**BEFORE THE PUBLIC UTILITY COMMISSION
OF OREGON**

LC 82

2023 Integrated Resource Plan

**SIERRA CLUB'S ROUND 1 COMMENTS ON
PACIFICORP'S 2023 INTEGRATED RESOURCE PLAN**

Figure 2: Modified Version of Figure 8.2

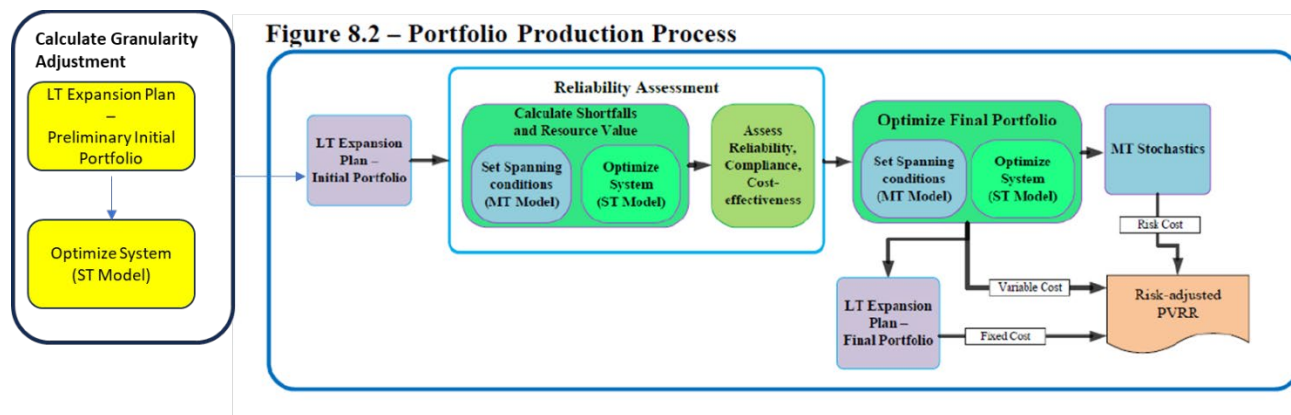
As PacifiCorp explained, this calculation reflects the “difference in economic value between an hourly 8760 cost calculation in ST modeling, and the seven-block per month representation used in the LT model.”³⁴ More specifically, for each resource type, the granularity adjustment reflects the difference in net revenues generated by the resource when comparing the ST model results and the LT model results of the preliminary initial portfolio. This difference in net revenues is then converted to an annual \$/kW-yr cost adjustment factor that is applied to each resource during the initial portfolio selection process for subsequent LT model runs. For example, if a battery’s flexibility allows it to generate more revenue during the hourly ST model than what the preliminary initial LT model suggested, the granularity adjustment would be in the form of a downward (i.e., negative) adjustment to the battery’s resource cost in the initial portfolio LT model run. This downward adjustment would make the battery more attractive for economic selection in subsequent initial portfolio LT model runs.

Based on Sierra Club's review of the granularity adjustment values provided by PacifiCorp, there are several values that appear counterintuitive and without a clear explanation.³⁵ First and foremost, Sierra Club is concerned that virtually all of the existing coal units tend to have relatively large negative granularity adjustments, often reaching the minimum value of - \$ [REDACTED] /kW-yr through 2030 and even beyond in some cases. This trend is at odds with the fact that most coal units are relatively inflexible and would likely not be capable of fast ramping activities that would allow them to quickly adjust their economic dispatch. Thus, in contrast to a resource like a battery, it is unclear why the ST model would demonstrate greater net revenues for coal resources than the LT model.
